H STREET HOTEL  
Washington, DC

BZA APPLICATION

Board of Zoning Adjustment  
District of Columbia  
CASE NO. 18772  
EXHIBIT NO. 42B

Cellar Plan  
1/16" = 1'-0"

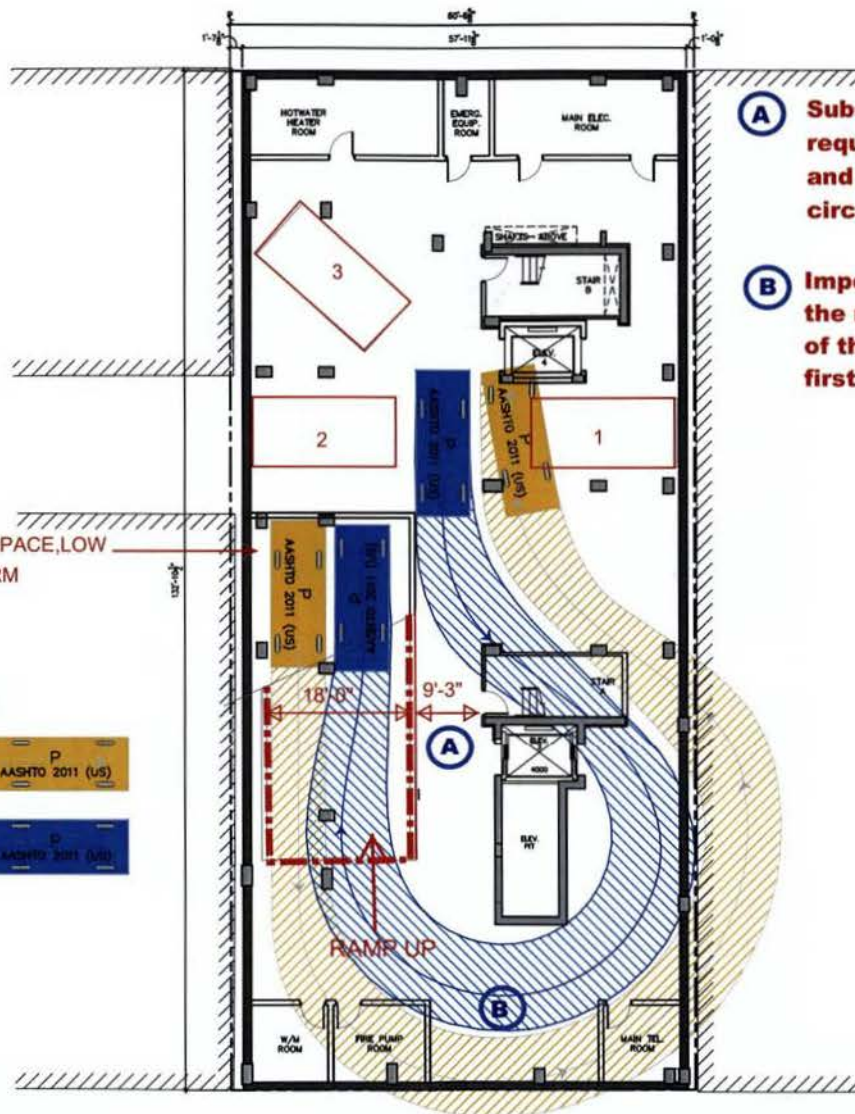
**A** Substandard drive aisle of only 9'-3" feet (versus requirement of 20 feet) given the core locations and fire exit stairs which prevents two way circulation in the garage.

**B** Impossible for a car to navigate from the ramp to the drive aisle given the small size of the site and ramping needed to get to the first below grade level.

Lower Level Plan  
 1/16" = 1'-0"

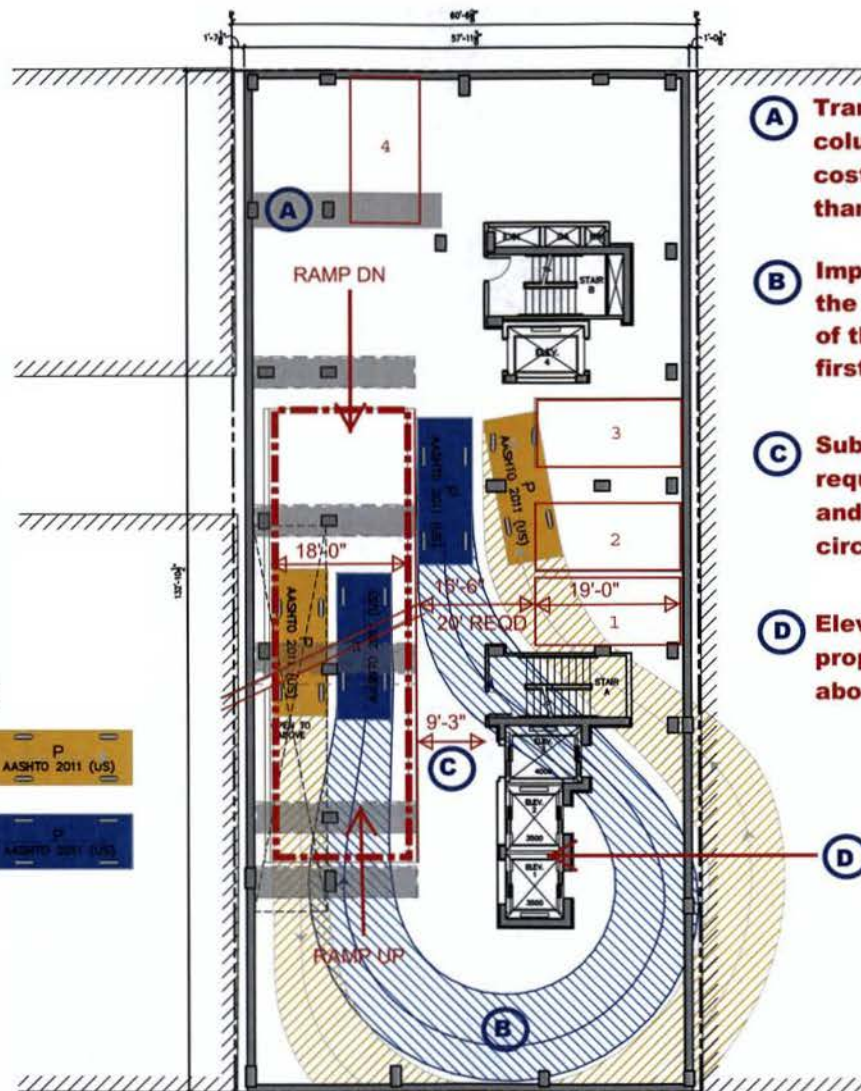
- (A)** Transfer girders are required to eliminate the columns from middle of ramp at a cost of minimum \$50,000 per girder and more than \$300,000 for all 6 girders.
- (B)** Impossible for a car to navigate from the ramp to the drive aisle given the small size of the site and ramping needed to get to the first below grade level.
- (C)** Substandard drive aisle of only 9'-3" feet (versus requirement of 20 feet) given the core locations and fire exit stairs which prevents two way circulation in the garage.
- (D)** Elevator core cannot be relocated toward property line due to needed open courtyard above.

A3

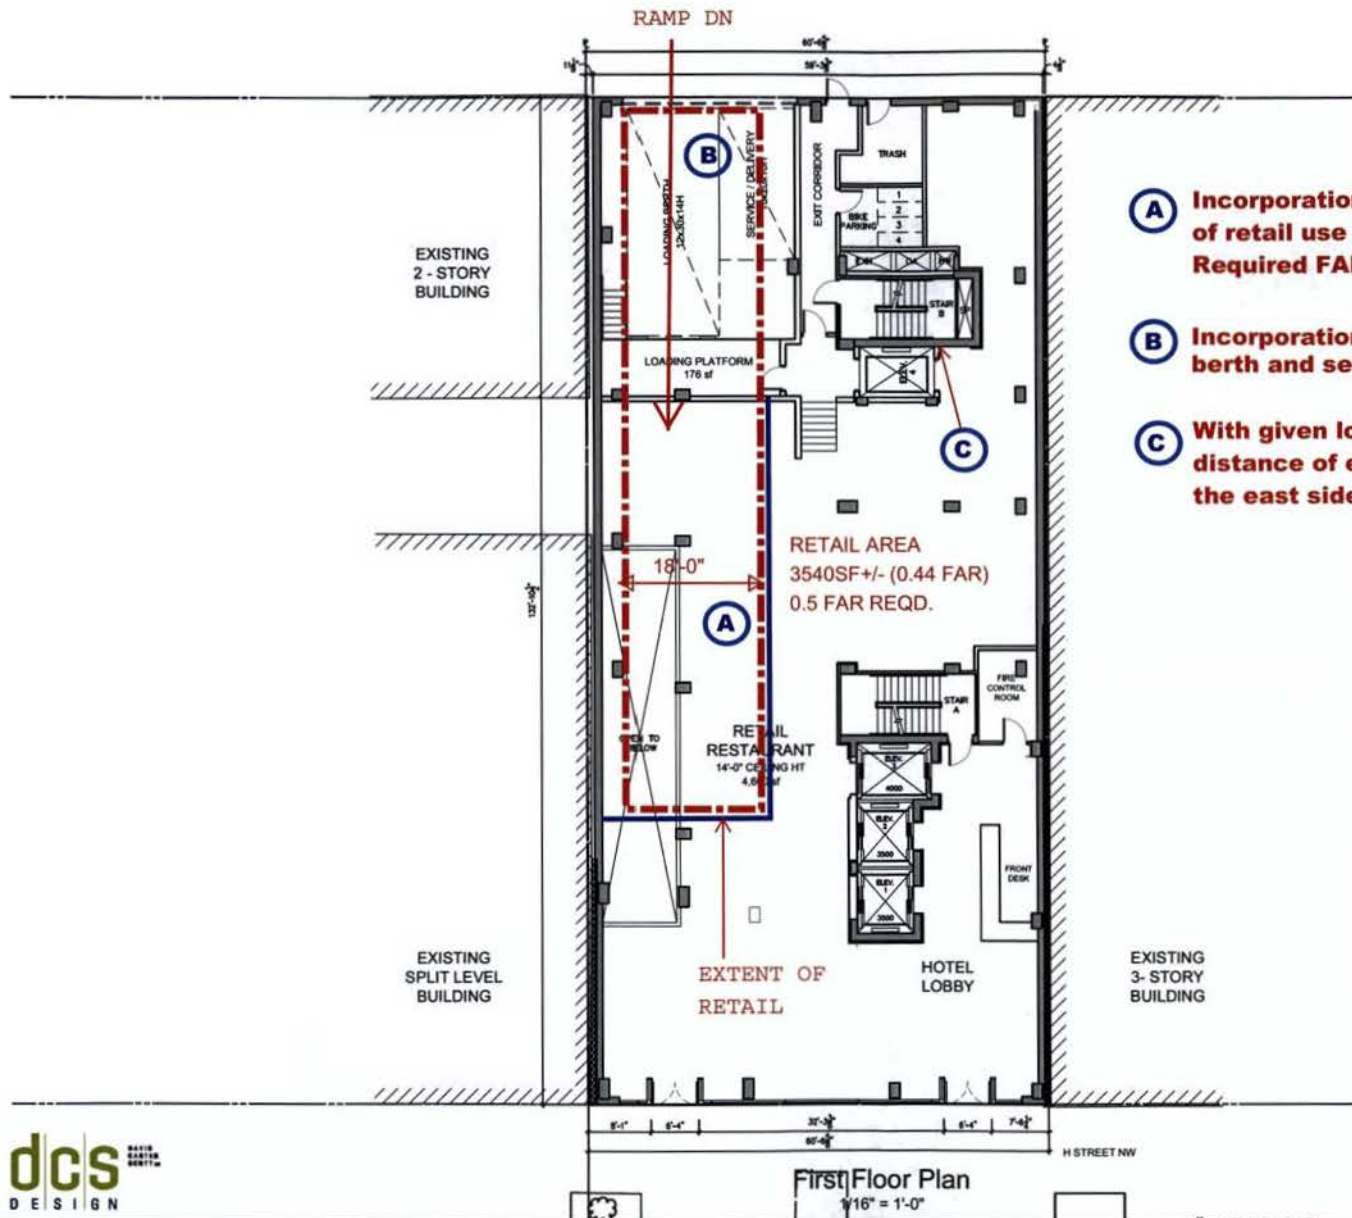
- (A)** Incorporation of parking ramp eliminates 1060 sf of retail use reducing the retail FAR to 0.44 Required FAR is 0.5.
- (B)** Incorporation of parking ramp eliminates loading berth and service/delivery space.
- (C)** With given location of core and code required distance of exit stair, loading berth cannot be on the east side of project.
